# EXHIBIT 9

**DEFENDANT'S SECOND REQUESTS FOR ADMISSION**

# EXHIBIT U

## **PCB Contractor Work Plan**

# Sketch A

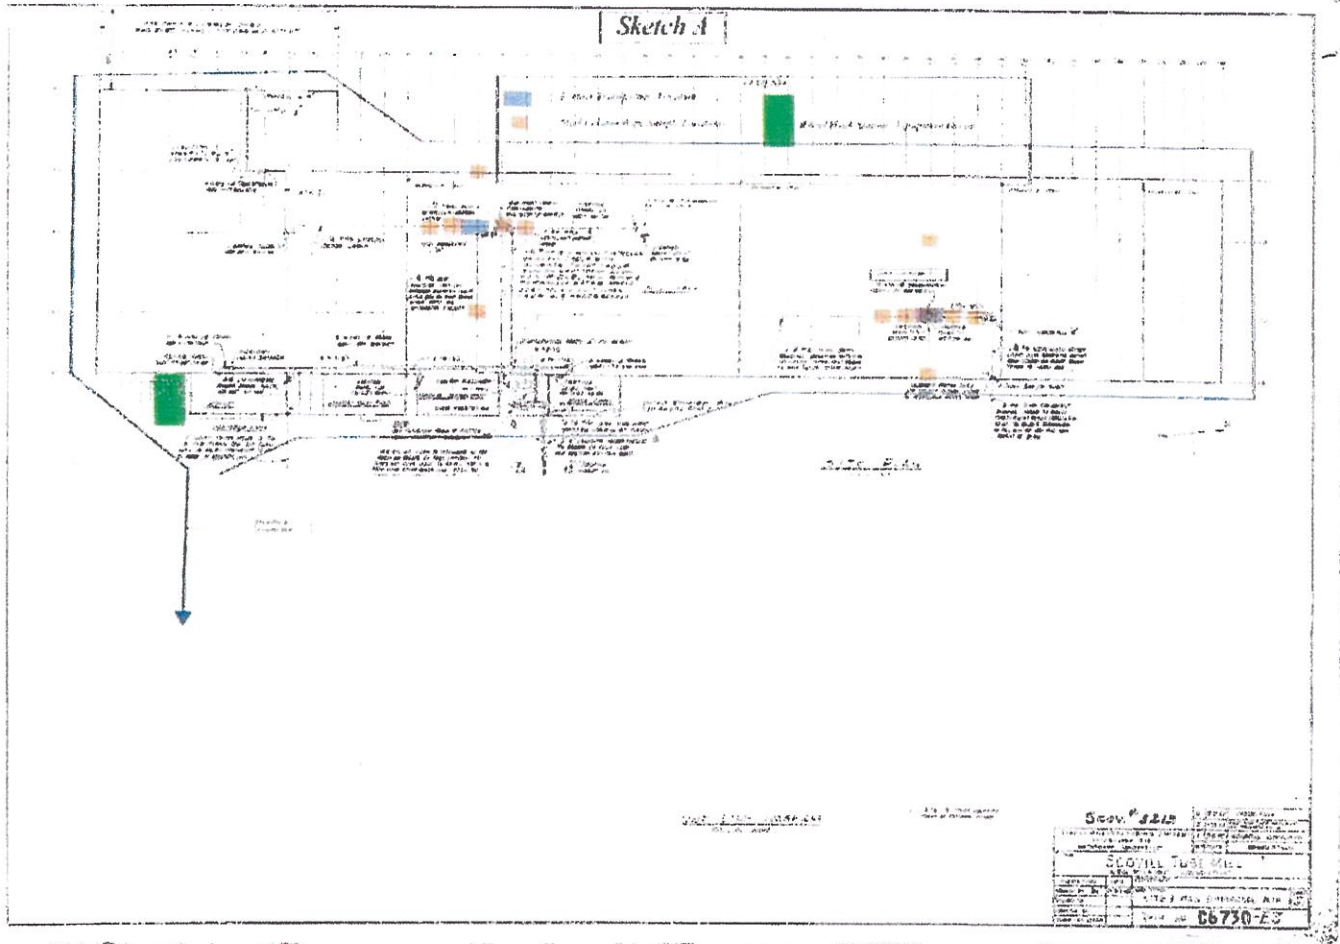
Pressure washing of truck tires that may be impacted by PCBs would not meet the decon requirements under 761.79(c). As a potential alternative to the 761.79(c) requirements, wipe sampling may be a possibility, but only for screening purposes (objective: no detectable PCBs) since the truck tires would likely be considered a porous surface.

What does EQ/NE plan to do with the wash water?

Decor provisions for tools/equipment are found at 761.79(c). With respect to the truck tires, does any equipment that would be used for the interior work have tires?

Please clarify the total number of beams present in the building. How many beams will be sampled initially?

Given how PCBs were spread at this facility, it is not clear that potential contamination would be limited to just that area of the building. Thus, some additional random sampling may be worthwhile.

For sampling the beams, EPA assumed that the wipes would be collected from the surfaces where dust would accumulate unless there was evidence of a direct release (e.g., staining).
